LEDGEWOOD GOLF COURSE

WATERFORD, CONNECTICUT

ENVIRONMENTAL REVIEW TEAM REPORT
ON

**LEDGEWOOD GOLF COURSE
WATERFORD, CONNECTICUT**

VEGETATION MAP

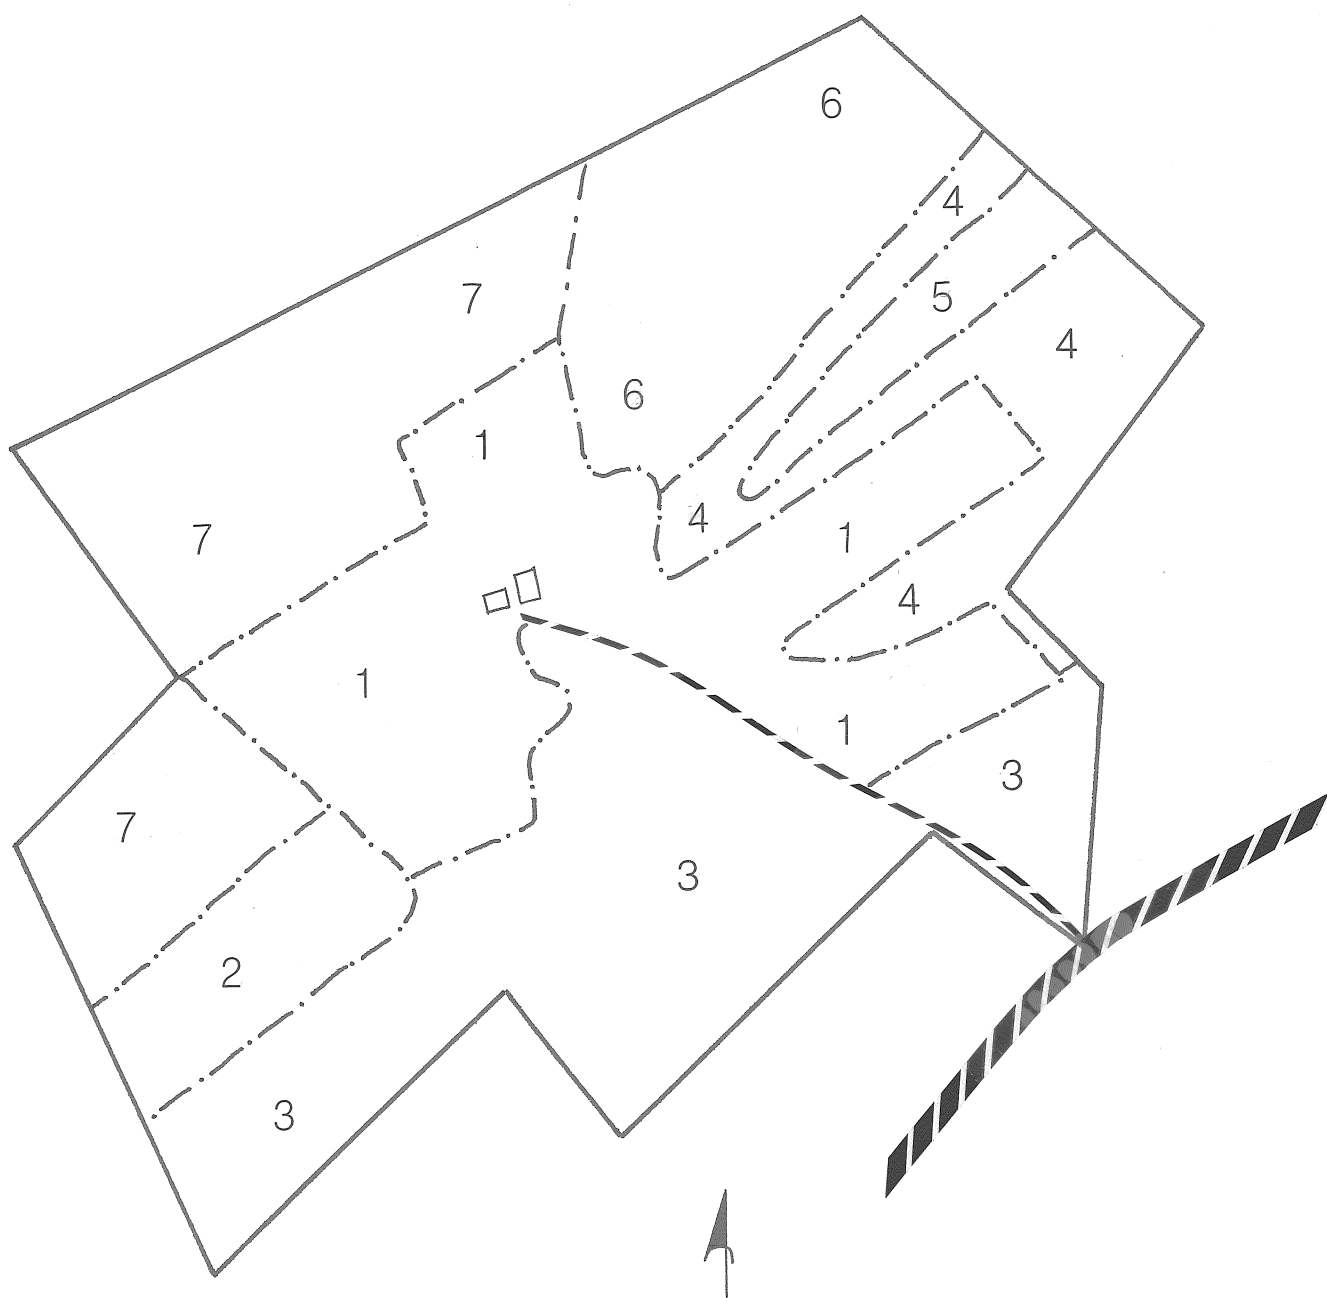
Sugar maples, hickories and red cedar are the best trees to leave exposed along the fairways and other open areas. They are less susceptible to changes in their environment caused by the sudden release than oaks and they are stronger as single stems than the birches. Tulip popular is the fastest growing tree and where they are open grown and have developed a broad canopy, they hold up well also.

AREAS TO BE ARCHAEOLOGICALLY TESTED

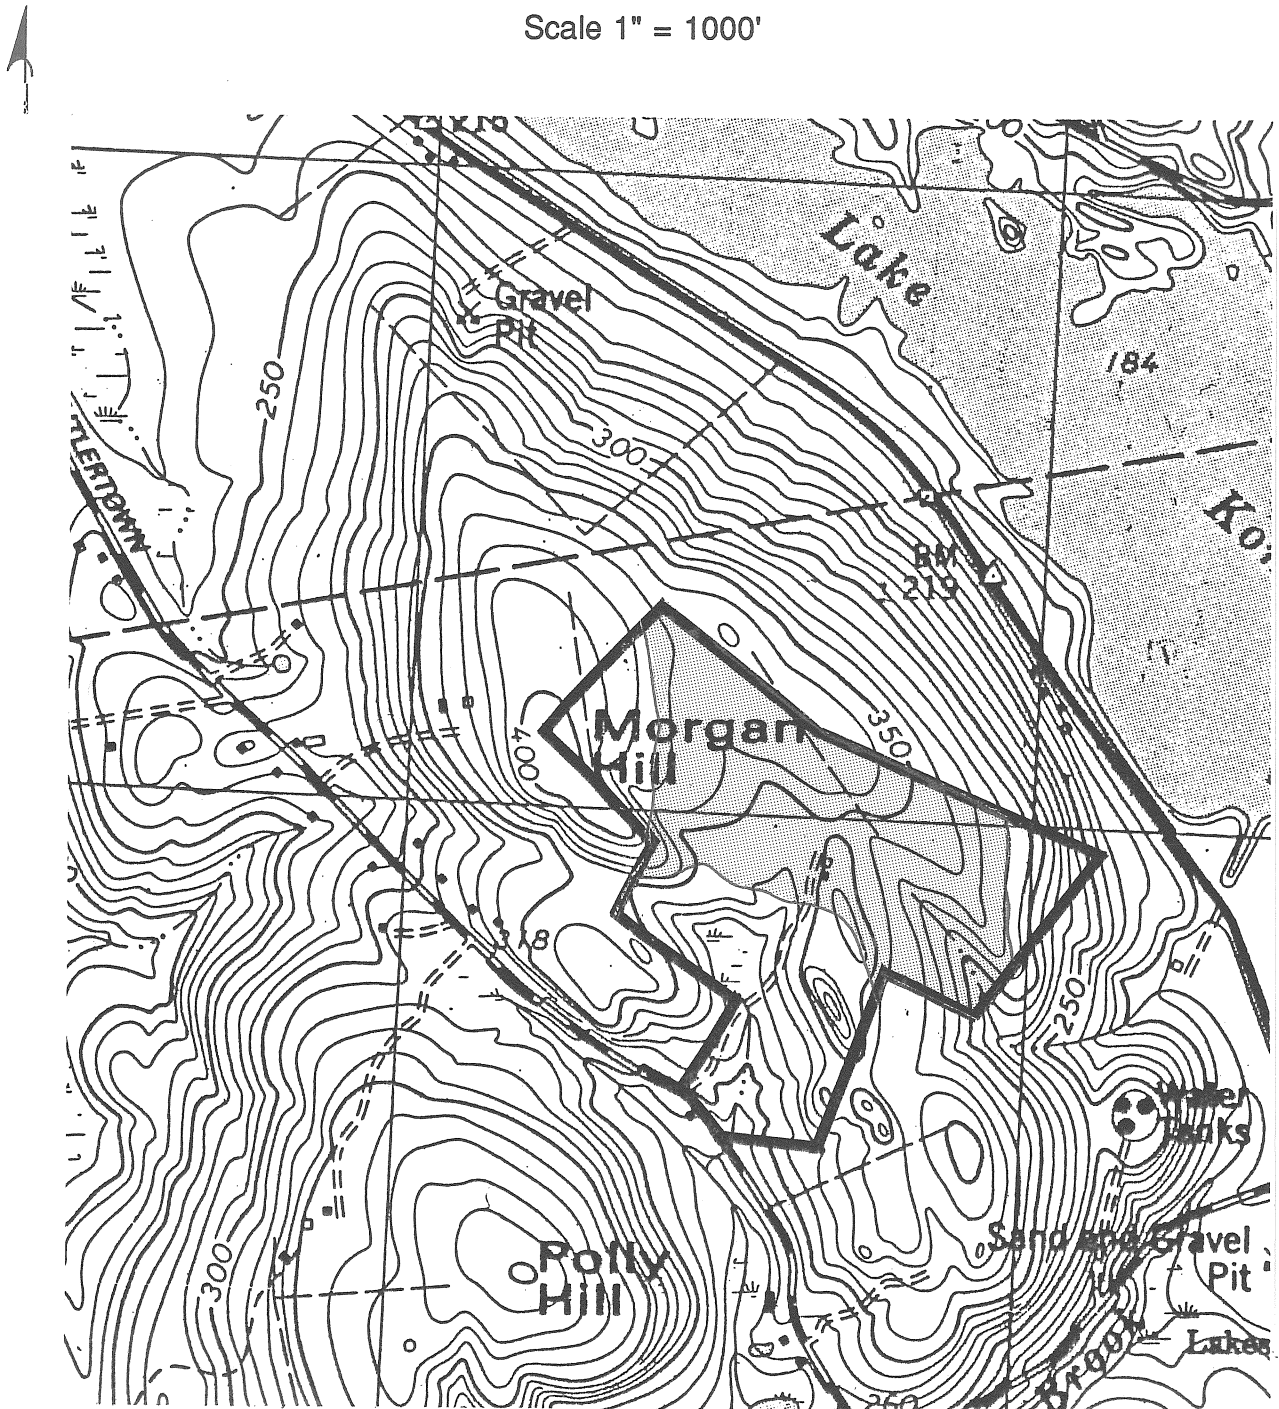
The Office of State Archaeology recommends that if extensive landscaping is proposed for the area at the knoll of Morgan Hill and along the brook draining into the lake there should be an archaeological reconnaissance survey conducted. This survey can locate and delineate any cultural resources in the project area and can be limited to the area outlined in the accompanying map. We further recommend that all archaeological studies be conducted in accordance with the Connecticut Historical Commission's **Environmental Review Primer for Connecticut's Archaeological Resources**.
